**Chicago Avenue Streetscape**
Village of Oak Park, IL

Questions and Comments from the Community March 9, 2006

Village Board Recommendations March 20, 2006

CURB CUTS BETWEEN HARVEY AND RIDGELAND

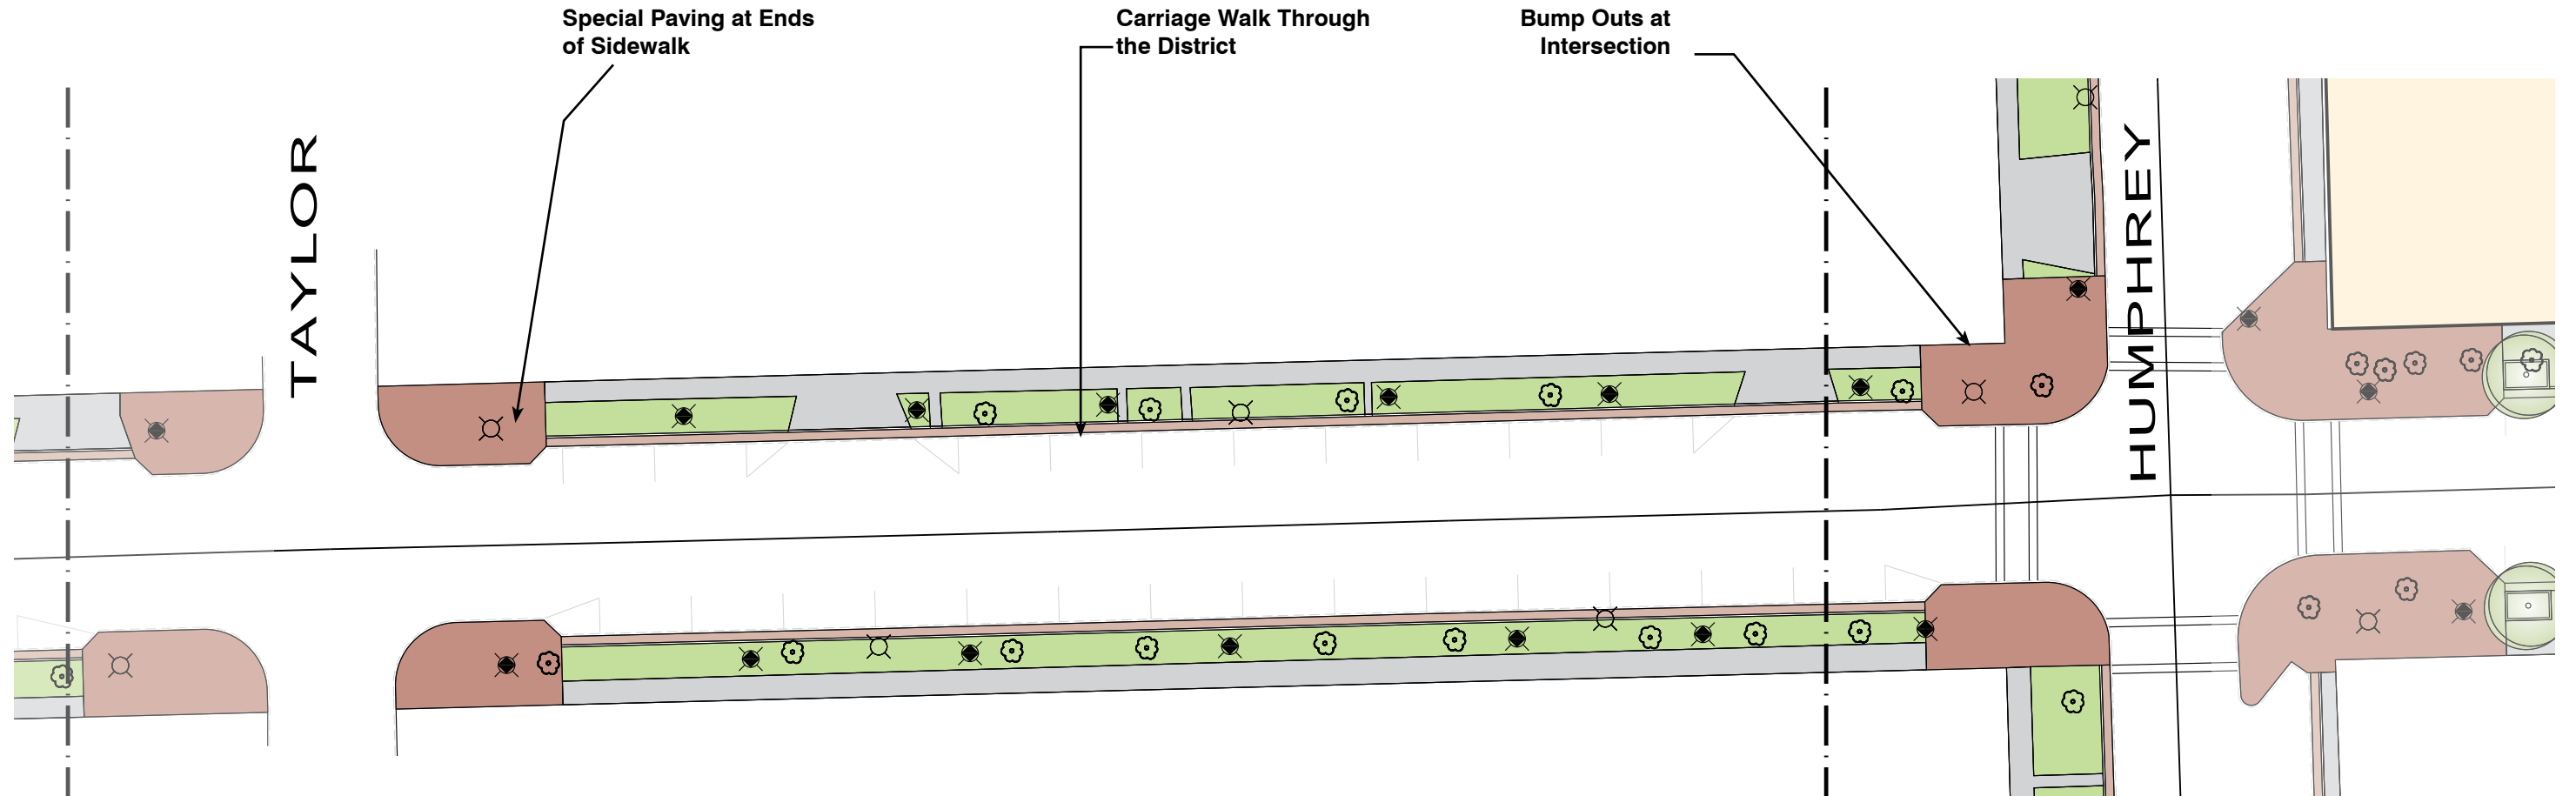
Comment: Close Harvey curb cut into 7-11 parking lot. Combine parking lot with two property owners and provide access off of Chicago Avenue.

Northwest Corner of Harvey/Chicago (Street Level)

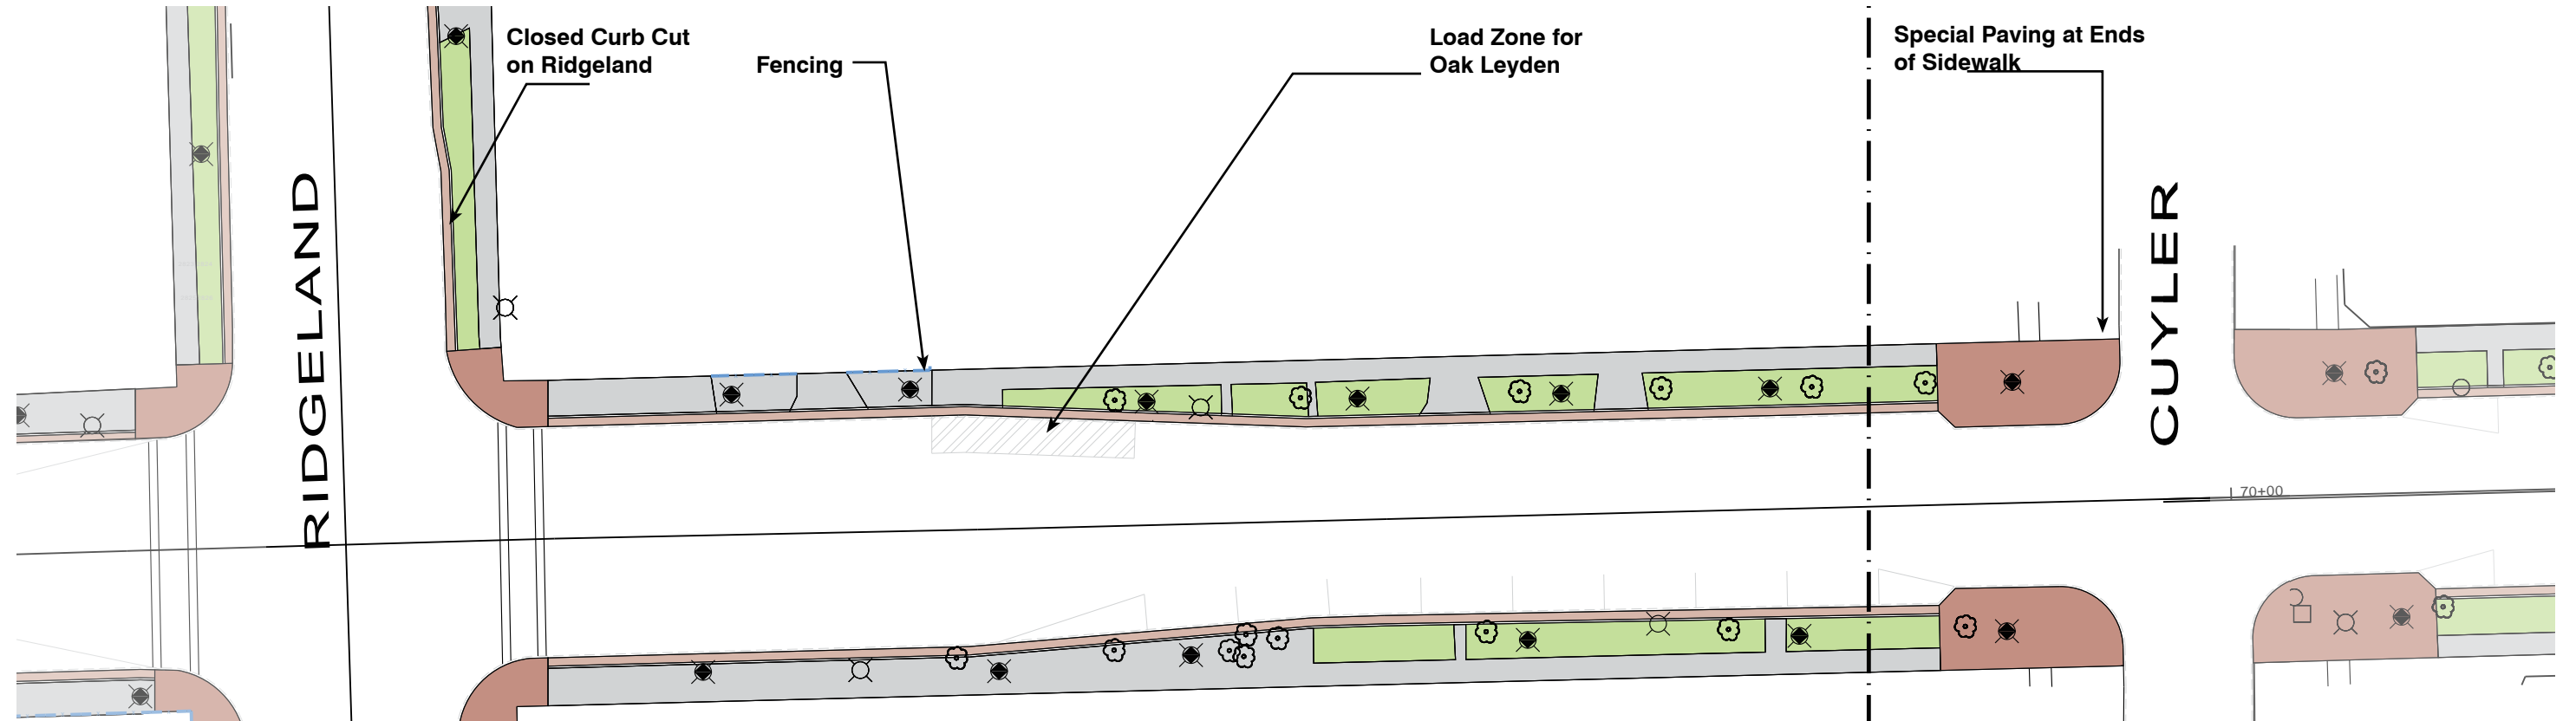
Q: Is the 7-Eleven going to agree to put the fence on their property? Will there be any coordination with the property owners?

A: The 7-Eleven will be contacted by the Village on this matter, and if agreeable the fence will be covered as part of the costs for the streetscape project.
